Process Sheet

Customer : CU-DAR001 Dart Helicopters Services	Drawing Name : PLUG
Job Number : 48273	
Estimate Number : 12337	
P.O. Number :	Part Number : D34923
This Issue : 28/05/2009 S.O. No. :	Drawing Number : D3492 REV C
Prsht Rev. : NC	Project Number : N/A
First Issue : / / Type : MACHINED PARTS	Drawing Revision : C
Previous Run : 47473	Material :
Written By :	Due Date : 04/06/2009 Qty: 20 Um: Each
Checked & Approved By : <u>Julie Dawson</u>	
Comment :

DART AEROSPACE LTD HAWKESBURY, ONTARIO, CANADA	
DRAWING NO. D3492	REV. C
TITLE PLUG	SHEET 1 OF 2
SCALE 2:1	
COPYRIGHT © 2007 BY DART AEROSPACE LTD. THIS DOCUMENT IS PRIVATE AND CONFIDENTIAL AND IS SUPPLIED ON THE EXPRESS CONDITION THAT IT IS NOT TO BE USED FOR ANY PURPOSE OR COPIED OR COMMUNICATED TO ANY OTHER PERSON WITHOUT WRITTEN PERMISSION FROM DART AEROSPACE LTD.

DRAWING NO. D3492	TITLE PLUG	REV. C	DART AEROSPACE LTD ENGINEERING ORDER		D.E.O. NO. D3492-C-1	SHEET NO. SHEET 1 OF 1	SCALE NTS
DRAWN AJS	CHECKED	MFG. APPR.	APPROVED		DE APPR.		
DATE 08.11.05	DATE 08.11.05	DATE 08.11.05	DATE 08/11/05		DATE 08/11/05

DETAIL D

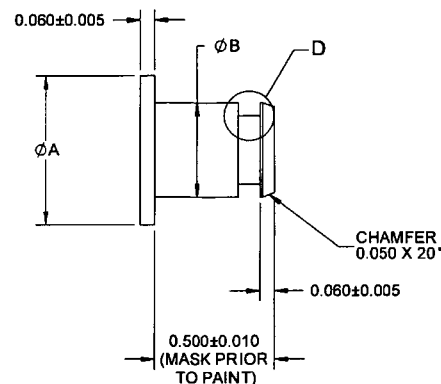
SHEET 2 MODIFY -13 PLUG AS SHOWN:

IS:

P/N	A	B	C	MATERIAL SPEC
D3492-13	0.750	0.510	0.045	M6061T6R0.750

WAS:

P/N	A	B	C	MATERIAL SPEC
D3492-13	0.750	0.520	0.045	M6061T6R0.750
